DeKalb County Zoning Board of Appeals

Planning Department Staff Analysis

D1. Case No: A-26-1247815 **Parcel ID(s): 18 047 21 017**

Project Name: **3140 Kelly Street – New Home Construction**

Site Plan

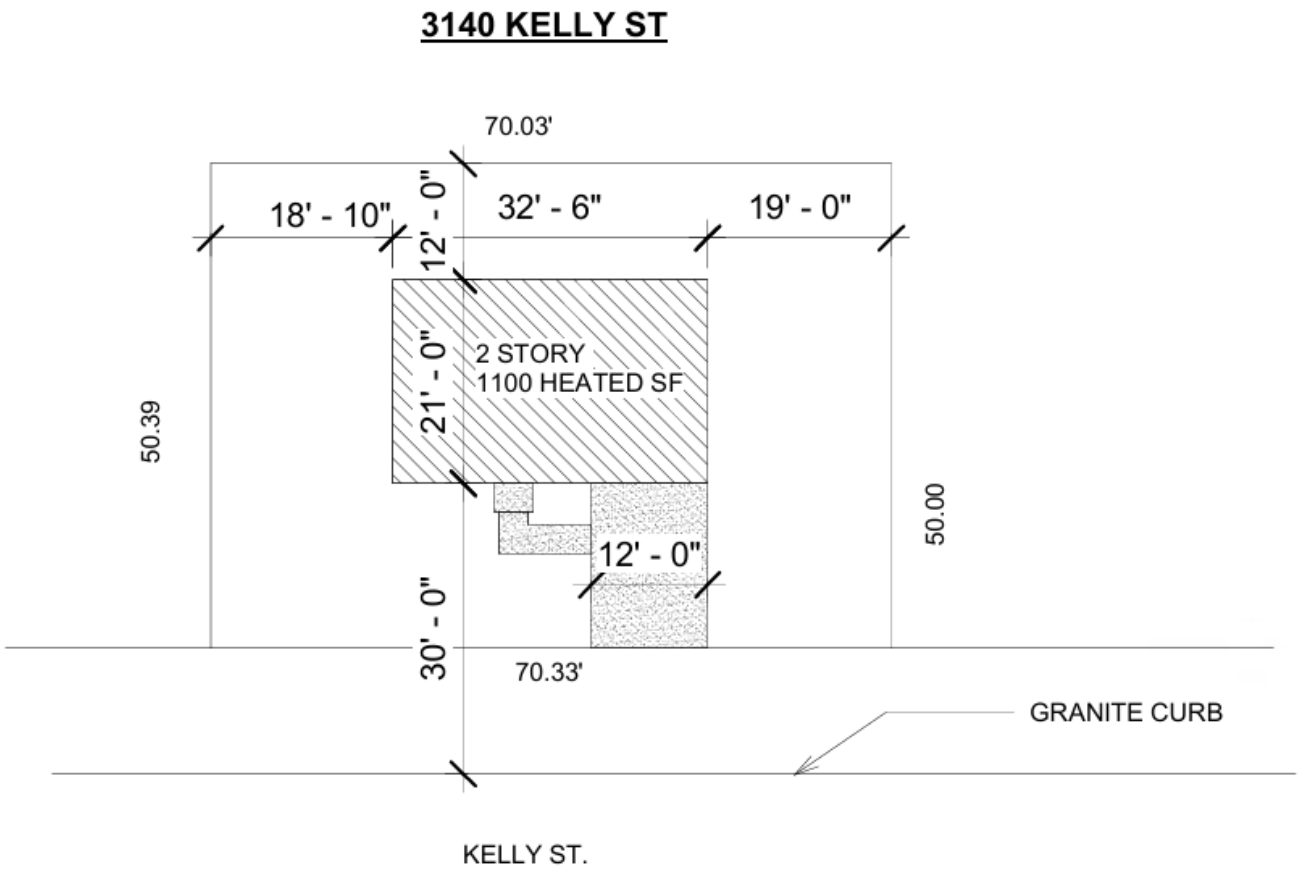
However, staff is unable to determine whether the requested reduction represents the minimum relief necessary due to deficiencies in the submitted site documentation. The materials provided do not include a certified, sealed survey or site plan depicting property lines, required setback lines, and the precise placement of the proposed structure. Without this information, staff cannot verify whether the dwelling could be reasonably sited with a lesser rear setback reduction. However, compared to the previous request as case #1247100, it is a favorable reduction.

1. The following information about this variance shall be noted on any site plan prepared for the subject property: case number, approval date, type of variance, and condition(s) of approval.
2. The site plan submitted for permit review shall be prepared and stamped by a Georgia-registered engineer or land surveyor and shall include all required property dimensions.
